Access Compliance Report Public Rights-of-Way (Curb Ramps)

Main Street: MCFADDEN_AVE Cross Street: VAN_BUREN_ST Location: SE

ADA ID: RPRK220202115942 Ramp Type: Type 4 - Parallel Initial Pass/Fail: Fail Overall Compliance: No Severity Score: 16

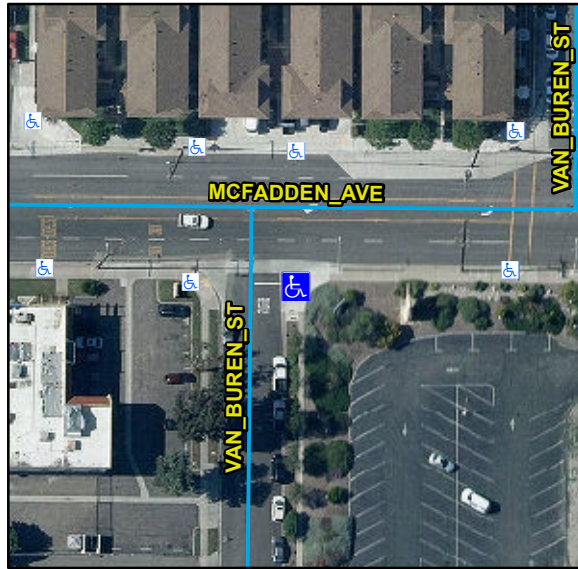
R304.5.3, R304.3.2, STD 1115

Compliance	Description	Data	Compliance	Description	Data
N/A	Ramp Length LT (in)	87	N/A	Ramp Length RT (in)	82
Yes	Ramp Width LT (in)	93	Yes	Ramp Width RT (in)	93
Yes	Ramp Run Slope LT (%)	8.1	No	Ramp Run Slope RT (%)	8.4
No	Ramp Cross Slope LT (%)	2.1	Yes	Ramp Cross Slope RT (%)	2
N/A	Landing Present	N/A	N/A	DWS Provided	N/A
N/A	Landing Length (in)	N/A	N/A	DWS Contrast	N/A
N/A	Landing Width (in)	N/A	N/A	DWS Length (in)	N/A
N/A	Landing Run Slope (%)	N/A	N/A	DWS Full Width	N/A
N/A	Landing Cross Slope (%)	N/A		DWS Offset Type	N/A
N/A	Landing Movement Obstructed?	N/A	N/A	DWS Offset Left (in)	N/A
	Landing Movement Type	N/A	N/A	DWS Offset Right (in)	N/A
N/A	Landing Shared	N/A			
N/A	Clear Space	Yes			
N/A	Clear Space To Crosswalk (in)	N/A			
N/A	Marked Crosswalk 1	No	N/A	Marked Crosswalk 2	No
	Crossing 1 Direction	N		Crossing 2 Direction	W
	Marked Crosswalk 1 Width (in)	N/A		Marked Crosswalk 2 Width (in)	N/A
N/A	Ramp Inside Crosswalk 1	N/A	N/A	Ramp Inside Crosswalk 2	N/A

Remove & Replace Curb Ramp With Two New Directional Ramps or Equivalent.
